BABCOCK, JONES AND ASSOCIATES, INC CIVIL ENGINEERS - SURVEYORS - LAND PLANNERS PAINESVILLE OHIO 44077

SITE PLAN FOR CEDARCRAFT LOG HOMES CONCORD TOWNSHIP LAKE COUNTY STATE OF OHIO

SCALE 1"=40' JOB NO 03-147 SHEET 1 OF 2

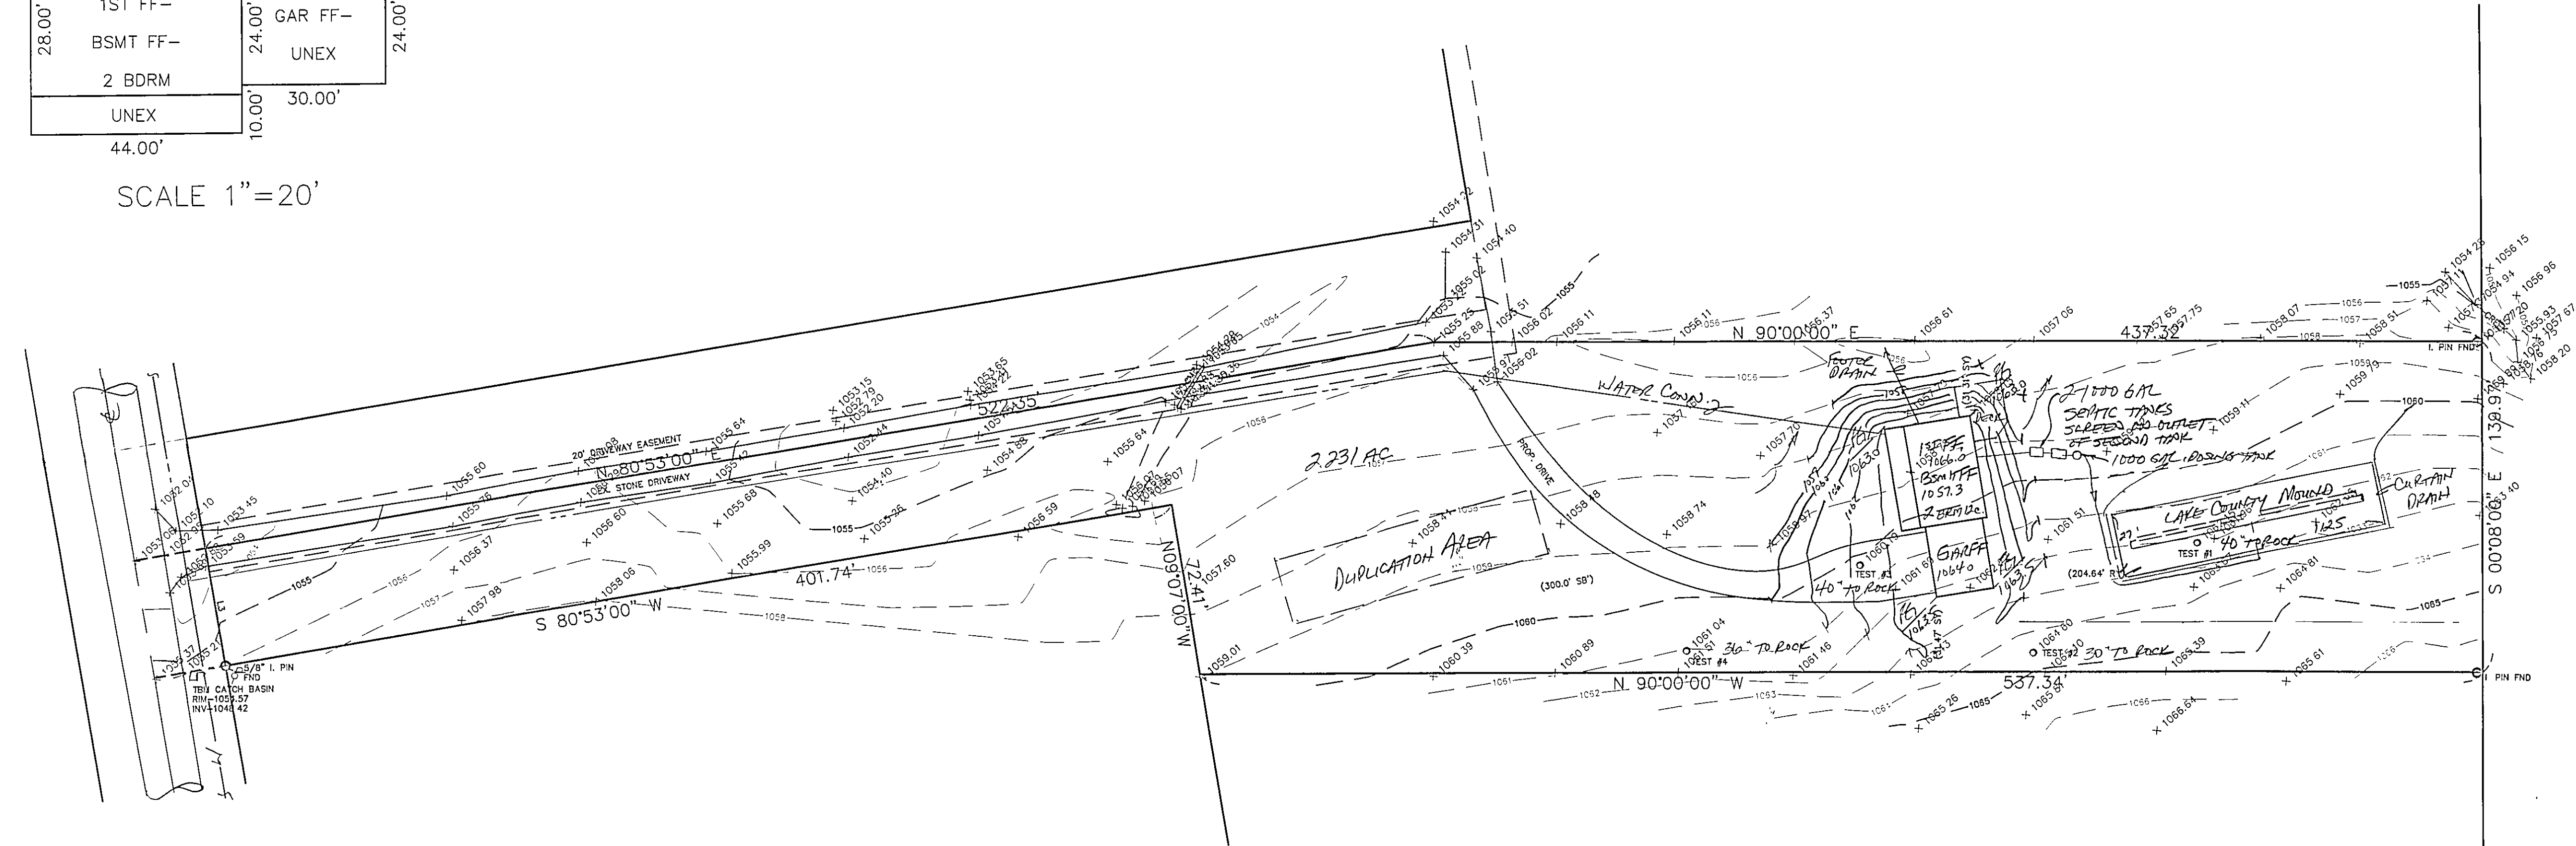
Grading Plan Approved as shown and/or noted JAMES R. GILLS, P.E. Lake County Engineer By: [Signature] Date: 7/3/03 Discharge Footer Drain to defined drainage channel
